UNITED STATES PATENT AND TRADEMARK OFFICE

APPLICATION NO.	FILING DATE	FIRST NAMED INVENTOR	ATTORNEY DOCKET NO.	CONFIRMATION NO.
10/523,972	02/08/2005	Eiji Kadouchi	43890-715	1562

Office Action Summary

DETAILED ACTION

Fig. 44

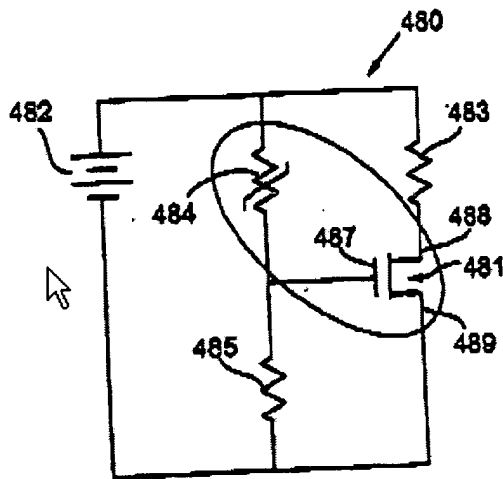
Thomas discloses in Figure 44, and paragraph 0193, a heating resistor increases automatically so that heat generating current stops, and the independent discharge circuit is electrically connected to the battery (see below)

[0193] In accordance with this aspect of the inventions disclosed, PTC device 484 is thermally coupled to the FET device 481 as a protection against failure of the FET device 481 in case of overcurrent. As the voltage across the PTC device 484 and, therefore, the voltage across the FET device 481, approaches a level that might otherwise cause the FET device 481 to fail, current flowing through the PTC device 484 will suffice to raise the temperature of the PTC device 484 to its trip temperature. Once PTC device 484 trips to its high resistance state, the voltage across the device 484 will immediately drop to a level below the threshold gate voltage of the FET device 481, causing the FET device 481 to turn OFF.

It would have been obvious to a person having ordinary skill in the art at the time of the invention to add McMahan's heater circuit and Thomas's PTC battery temperature control means in Hashiguchi's system to protect the battery by cutting off the current when excessive current flows through the batteries or when battery temperature rises abnormally, and to increase effective usefulness of the battery during extreme cold conditions.

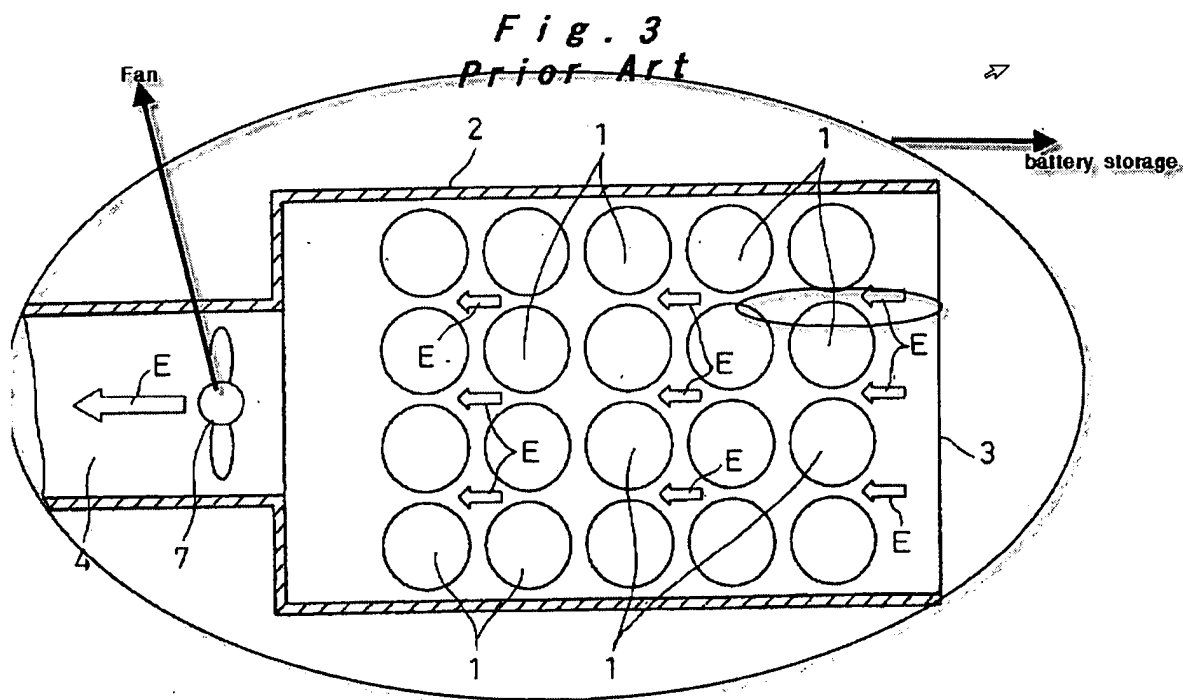
Regarding Claim 14, Oshida discloses in Figure 22, a plurality of heat conducting fins (152), a heat conducting body (154) located at said opening for conducting heat

between said plurality of fins, wherein said heat conducting fins communicate with said heat conducting body.

It would have been obvious to a person having ordinary skill in the art at the time of the invention to modify the opening of Hashiguchi's system and add a heat conducting plate and fins as taught by Oshida to provide exchange heat highly and efficiently.
